This manuscript presents an unprecedented evaluation of 23 (sub)daily (quasi)global precipitation (P)datasets across 16,295 catchments worldwide using hydrological modeling. The 23 P datasets belong to six major families of data sources: satellite only, reanalysis only, rain gauge only, satellite and rain gauge, satellite and reanalysis; and satellite, reanalysis and rain gauge. The conceptual hydrological model HBV was used to simulate the conversion of precipitation into streamflow at the daily temporal scale. Each P dataset, along with air temperature (from MSWX) and potential evapotranspiration (computed using the Hargreaves formula), are used to drive the hydrological simulations. The modified Kling-Gupta efficiency (KGE') is used to evaluate the performance of the simulated streamflows against daily observations, and serves as a proxy for the performance of the P datasets.

This manuscript addresses an important topic for the hydrometeorological community. The manuscript is well written, concise and clear, with updated references. Unfortunately, the manuscript lacks a clear scientific question or hypothesis to be tested, and the Methodology section does not provide enough sci

Fig. S26. Kling-Gupta Efficiency values for P datasets in different scenarios of PCORR and SFCF calibration.

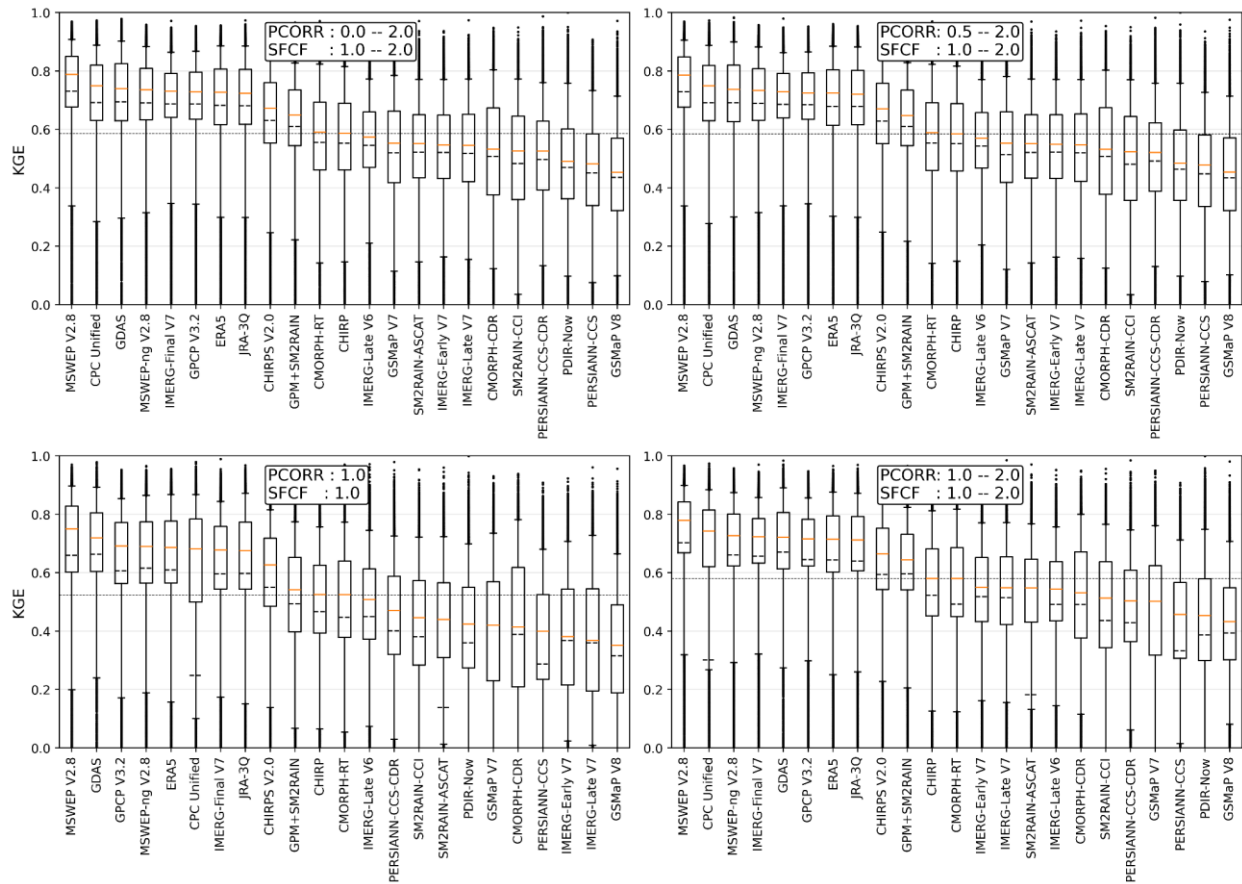
6. MC8. Range used for the calibration of the PCORR parameter of HBV. Table 2 shows that the PCORR parameter is used as a multiplier to mitigate the systematic underestimation of P characteristics of some P products, and therefore a range of [1, 2] is used in the optimisation of this parameter. This decision could lead to low KGE values in arid or hyper-arid catchments (see Table 3), where some P datasets overestimate the true (and unknown) P amount. Therefore, I request the authors to extend this range to [0.5, 2] so that the calibration procedure can compensate not only for an underestimation of P but also for an overestimation of it.

Response: Thank you for the useful comment. We compared the performance of the P datasets by calibrating KGE values under four different scenarios. In the first scenario, PCORR was allowed to vary between 0.0 and 2.0. In the second scenario, PCORR was restricted to the range 0.5–2.0. In the third scenario, both PCORR and SFCF were fixed at 1.0, as suggested by the reviewer (the 3rd reviewer). The fourth scenario corresponds to the one used in our original setup, where both PCORR and SFCF ranged from 1.0 to 2.0. The resulting ranking of precipitation datasets based on KGE is illustrated in the figure below

These results indicate that the overall ranking of P datasets do not vary significantly in all four scenarios. However, in scenario three (PCORR: 1.0, SFCF 1.0), the ranking of GPCP V3.2 and ERA5 improved. However, this improvement in ranking of these P datasets is not due to their improved KGE value since the overall median KGE value in scenario three is lower as compared to other three scenarios. The following figure illustrates the decrease in KGE when PCORR and SFCF were kept constant during calibration (third scenario) as compared to the default scenario when their values were allowed to vary between 1.0 to 2.0.

Fig. Percentage of stations for which the total number of generations reached 40 during calibration for each P dataset. We set 40 as the maximum number of generations to run for each catchment during calibration.

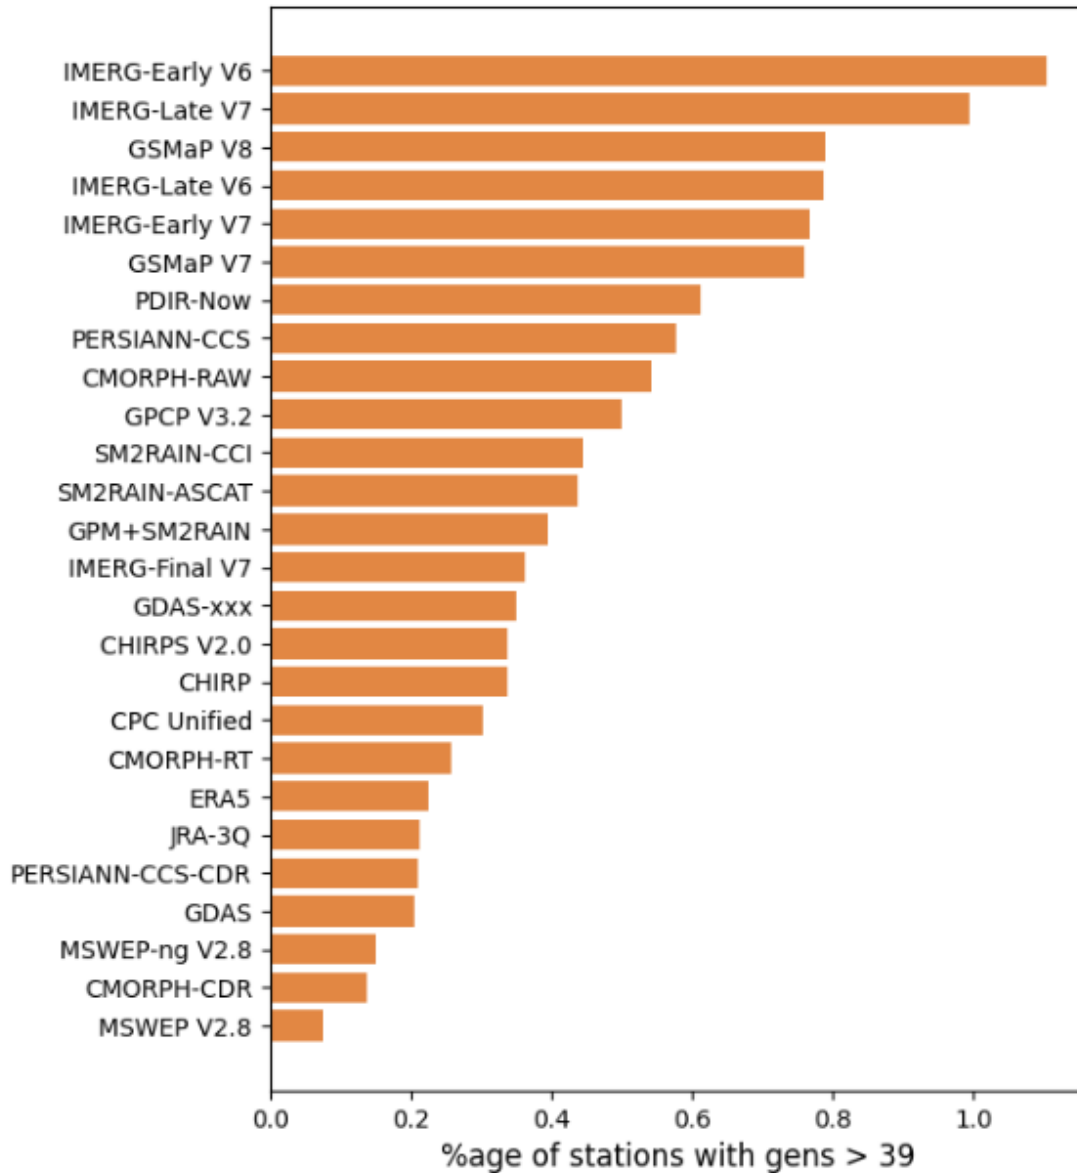
7. MC9. Use of an unknown version of the (μ+λ) evolutionary algorithm used to calibrate the HBV hydrological model. The manuscript does not contain a description of the version of the (μ+λ) evolutionary algorithm used to calibrate the HBV hydrological model. From L124, the reader can infer that the DEAP Python software was used to calibrate the HBV model. However, I request the authors to clarify the name and version of the software used to implement the (μ+λ) evolutionary algorithm and to describe how this algorithm was coupled to the (unknown) version of the HBV hydrological model (see MC5). Finally, I request the authors to describe whether they can ensure that the (μ+λ) evolutionary algorithm has converged to a stable KGE value after 1200 model runs (L125) or not.

Response: We used version 1.4 of the Distributed Evolutionary Algorithms in Python (DEAP) library. For the HBV, as responded previously, we used the HBV-light version of Seibert and Vis implemented in Python and used in previous studies (Beck et al., 2016, Beck et al., 2020, Feng et al., 2023, Feng et al., 204). During calibration of each catchment, the HBV model was run to simulate streamflow using the parameters suggested by the DEAP algorithm. The simulated streamflow is then compared against observed streamflow to calculate KGE values (Eq. 1 in the manuscript) which is then returned to the optimization algorithm as a feedback signal to its suggested parameters. The evolutionary algorithm of DEAP iteratively improves the suggested parameters which can improve KGE values. In order to ensure the convergence during calibration, we slightly modified the stopping criteria. The minimum number of generations was set to 25 and the calibration process was stopped if the KGE value did not improve more than 0.01 for more than 5 generations. However, to avoid computation loss, we set the maximum number of generations to 40. We found that less than 1% of stations were run for 40 generations which was the upper limit of the number of generations. This showed that for the overwhelming majority of catchments, the convergence was achieved before reaching the maximum number of generations and that further improvements were not possible, indicating that the optimal parameter set has been obtained.

Fig. Distribution of KGE values of P datasets in arid regions.

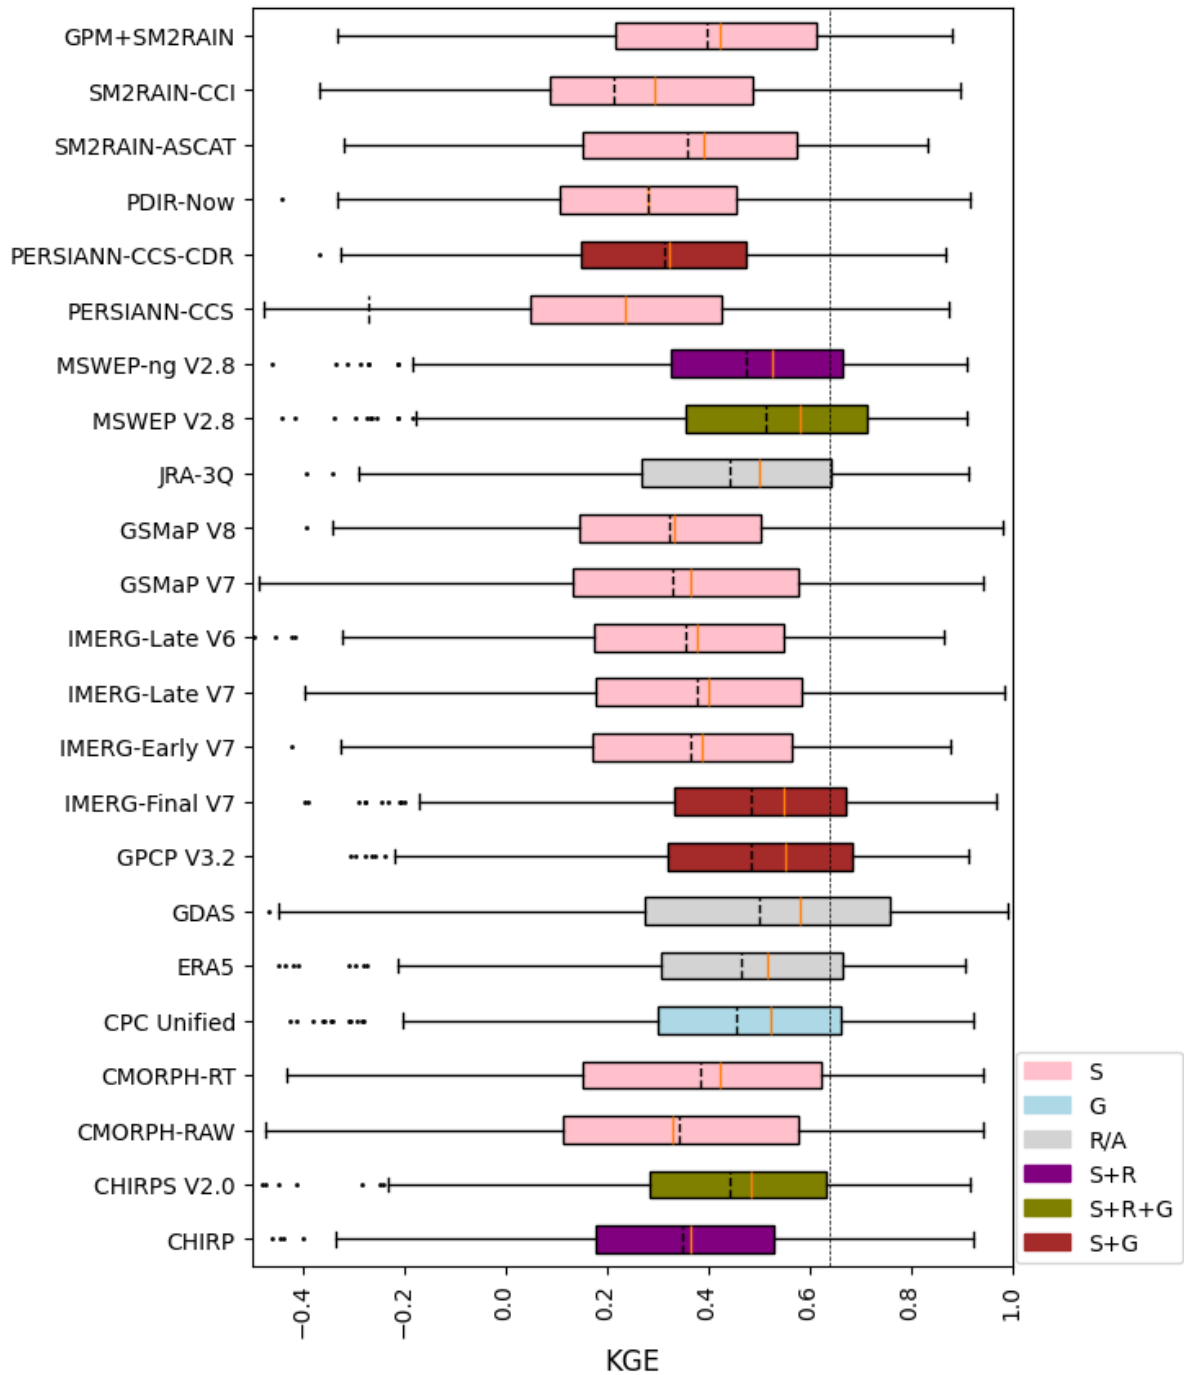
13. MC15a. Poor performance of HBV in arid climates. Although the manuscript does not explicitly mention this, it can be inferred that the authors assume that the performance of HBV is likely to be poor in arid climates (L226), because "*P in arid regions tends to be brief and intense, making it challenging to detect and model accurately(Beck et al., 2017b; Sun et al., 2018; El Kenawy et al., 2019; Beck et al., 2019a)*" (L227-228). However, Seibert and Bergström (2022) mention in their review that the HBV is routinely used to model the impacts of climate change on water resources around the world, including regions as arid as the Nile (Booij et al., 2011) and, threfore, aridity per se should therefore not be a reason to explain a poor performance of the HBV model.

Response: First of all, we would like to mention that we found a bug in our preprocessing of the African streamflow dataset (ADHI). Since the ADHI dataset contributes to most of the stations in arid regions, fixing this bug improved the median KGE for arid regions from 0.51 to 0.60. Second, you are right in pointing out that HBV has been applied around the world. There have been applications of HBV in arid regions but on fewer catchments. There have been very few studies who applied HBV on a global scale. However, the low performance of HBV in arid regions has been reported in several other studies. Feng et al. (2024) applied HBV, LSTM and a hybrid model combining HBV and an LSTM model on a global dataset and found that both perform poorly in arid regions with a median KGE value below 0.4. This indicates that even the data-driven deep learning models such as LSTMs performed poorly in arid regions. Booij et al. (2011) applied HBV in 17 subbasins of the Nile river and obtained a median KGE value of 0.64. However, they had a very small sample size (n=17) as compared to our study (n=1300). By plotting the distribution of KGE for arid regions from all P datasets as boxplot, we can show that KGE for a significant number of catchments went beyond 0.64 as shown in the figure below.

Fig. Calibration KGE for catchments with urban fraction less than 0.2.

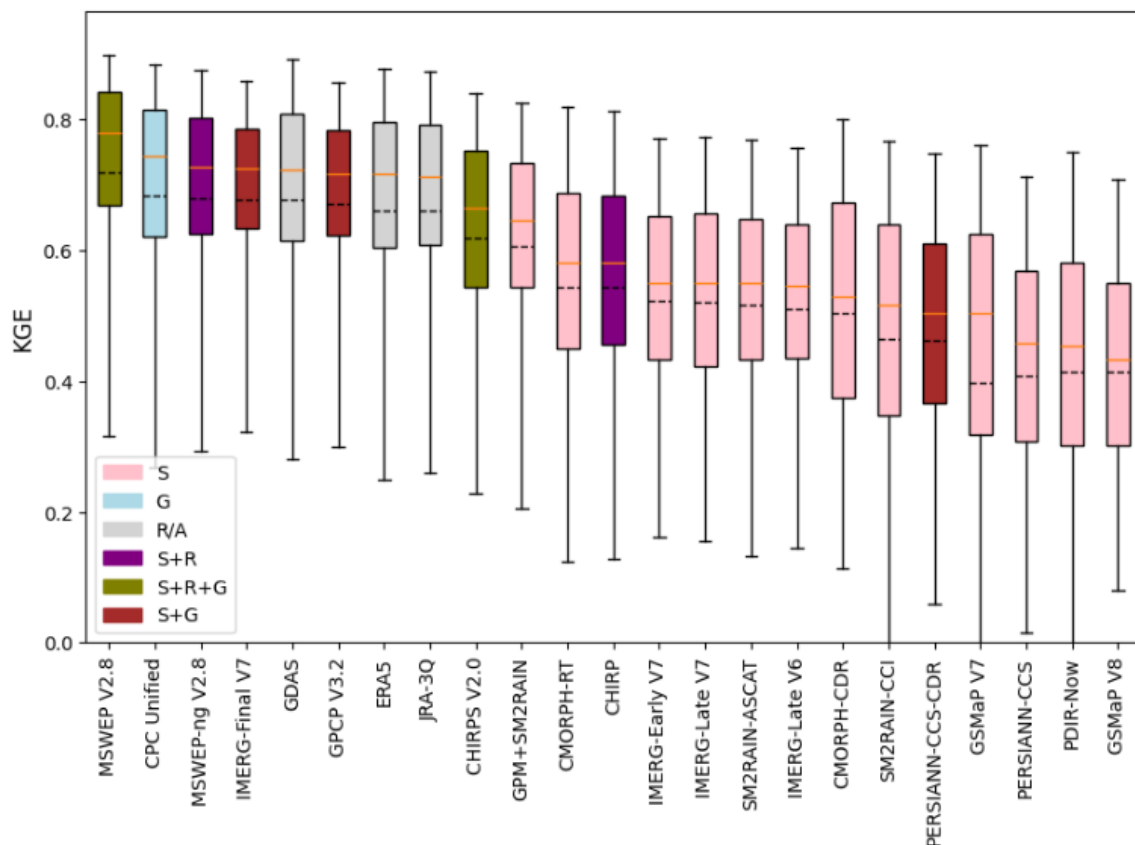
2. MC16. Efficiency of the filter used to select the study's catchmens. In Section 3.2 (Regional performance differences) the authors mention aridity, groundwater use and/or anthropogenic water use as possible explanations for the low performance obtained for several P products in Australia, India, South Korea and Africa. Does this mean that the five criteria used in Section 2.2 to "*ensure the suitability of the catchments for the present analysis*" (L87) did not work as expected?. I request the authors to add a discussion of why the five criteria previously mentioned were not sufficient to filter out catchments that were not suitable for the present analysis. I also request the authors to consider whether it is necessary to add one or more criteria that would allow the presence of irrigation, hydrograph regulation and/or major consumptive water use to be detected, in order to screen out catchments that will not provide reliable results from the analysis. I suggest the authors analyse the criteria used by the Reference Observatory of Basins for INternational hydrological climate change detection (ROBIN; Kumar et al., 2024) to ensure that the streamflows observed in each selected catchment are free from anthropogenic influences.

urbanization fractions below 10% for Tier 1 and 20% for Tier 2. Although we did not explicitly use urbanization fraction as a selection criterion, only 570 and 206 of our 18,428 selected catchments exceed the 0.1 and 0.2 urbanization thresholds, respectively. Furthermore, we found that excluding these 206 catchments does not significantly affect our overall findings: MSWEP V2.8 remains the top-performing dataset, with CPC Unified, IMERG-Final V7, GDAS, and MSWEP-ng V2.8 consistently ranking among the top five. The performance of all P datasets after excluding catchments with urban fractions greater than 0.2 are shown in the following figure.

Fig S29. Comparison of calibrated PCORR and corresponding KGE values from 531 catchments from CAMELS-GB using PDIR-Now P dataset.

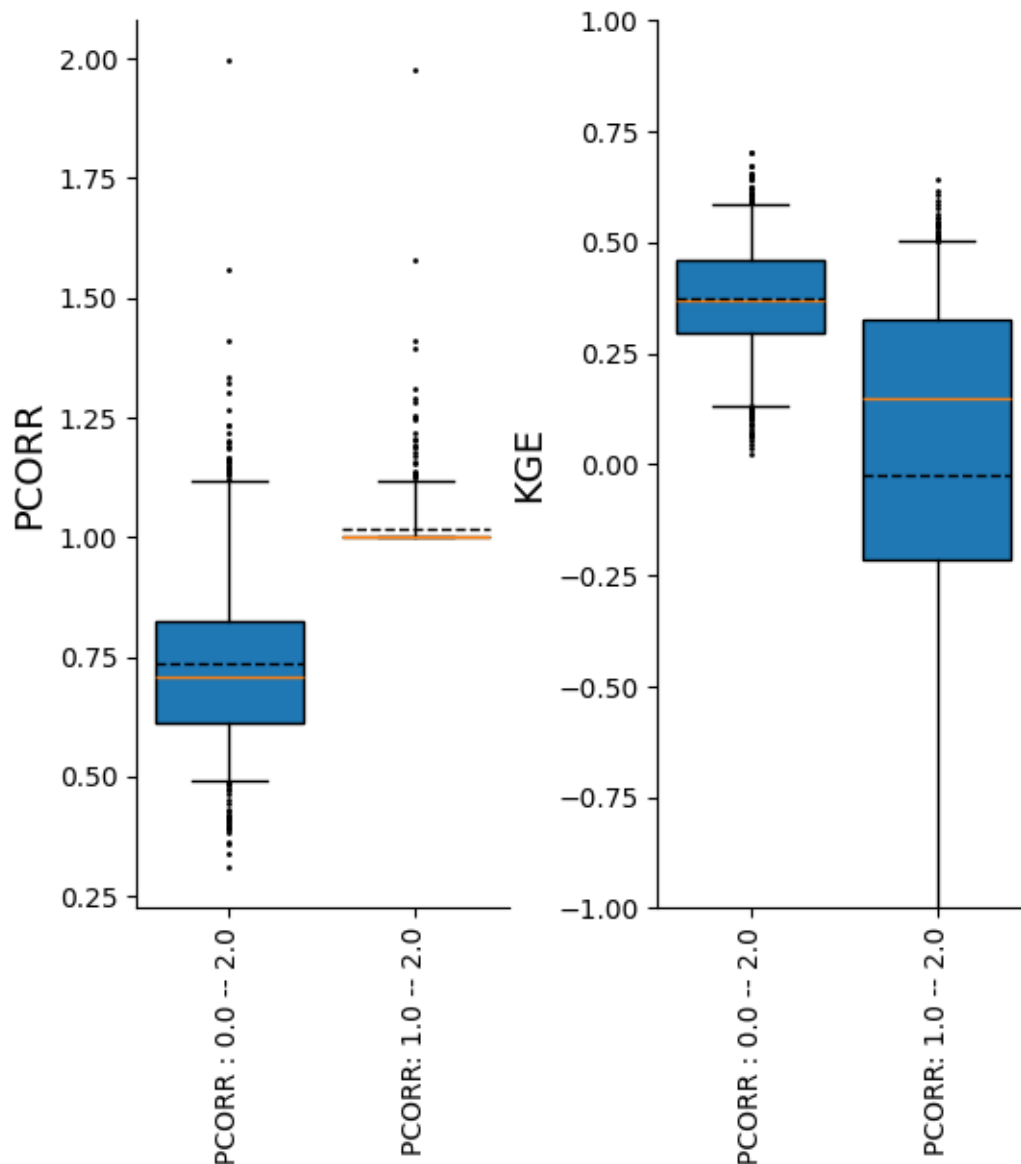
20. L174-175. Provide a discussion about the poor performance of PDIR-now in UK, Denmark and Italy.

Response: A detailed analysis of PDIR-Now's performance in the UK, Denmark, and Italy indicates that its lower performance can be attributed to the restricted lower bound of PCORR during calibration. Initially, the lower limit of PCORR was set to 1.0; however, when this limit was reduced to 0.0, the calibrated PCORR values decreased. The median calibrated PCORR values dropped to 0.76 for CAMELS-GB, 0.74 for Denmark, and 1.04 for Italy. As a result, the median KGE values for these countries improved to 0.39, 0.49, and 0.37, respectively. These findings suggest a consistent overestimation of precipitation by PDIR-Now in these regions.

Fig S52. Variation in HBV performance (KGE) with increase in slope.

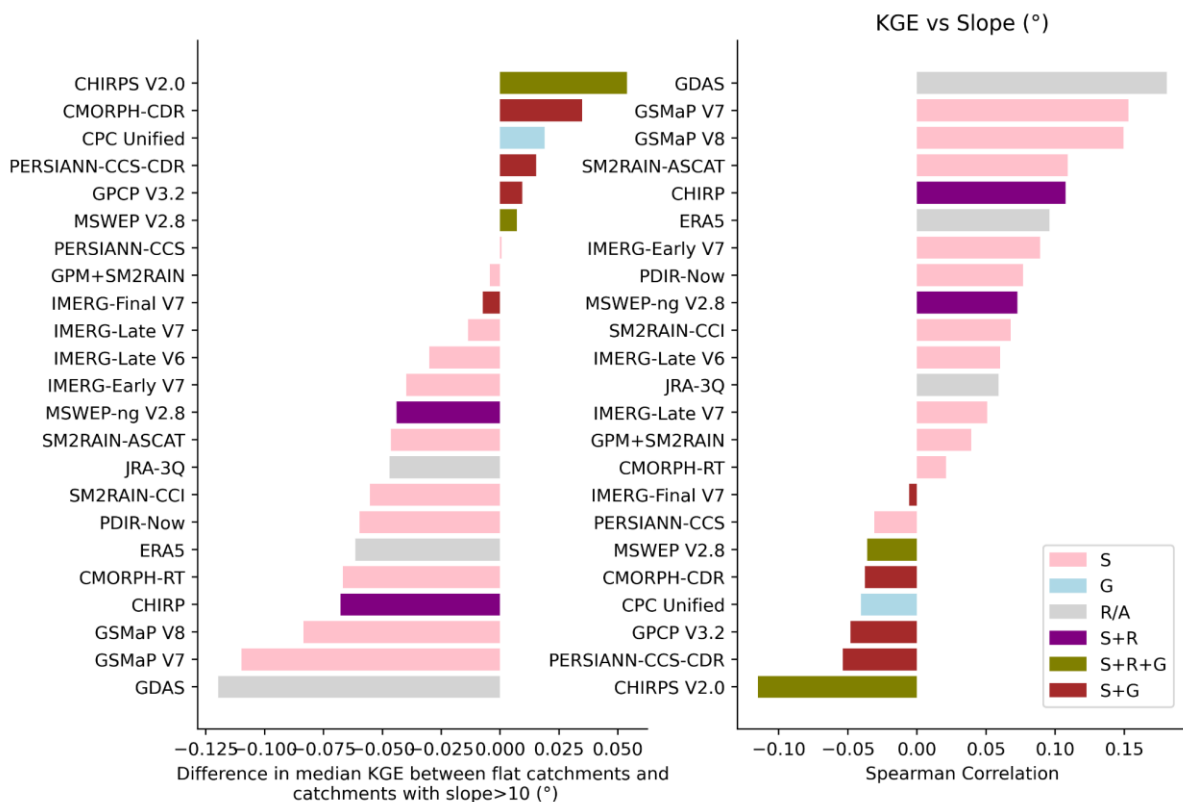
39. In the sections "*Results and Discussion*" and "*Conclusions*" please provide some analysis of the performance of the P datasets in mountainous regions, which is of utmost interest for the wider hydrological community.

Response: We analyzed the behaviour of all 23 P datasets with variation in slope and the results are illustrated in the following figure as bar charts. The first part of the figure indicates the difference in HBV performance between catchments with average slope less than 1 degree and the catchments with average slope greater than 10 degrees. The negative values indicate that the performance increased for catchments with

Lines 254 - 261 : "*The difference in model performance (median KGE) between flat and steep catchments (average slope > 10°) indicates that the performance of gauge-corrected P datasets tends to decrease in steep regions (Supplement Fig. S52a). This is reflected by a positive difference in median KGE between flat and steep catchments for gauge-corrected datasets. In contrast, for non-gauge-corrected P datasets, this difference is negative, indicating an increase in performance in steeper catchments. This pattern is further supported by the negative correlation between model performance (median KGE) and slope for most gauge-corrected datasets (Supplement Fig. S52b). This decrease in performance of gauge-corrected P datasets in mountainous regions can be explained by the sparsity of rain gauges (Kidd et al., 2017), which limits the effectiveness of gauge correction in those areas.*"
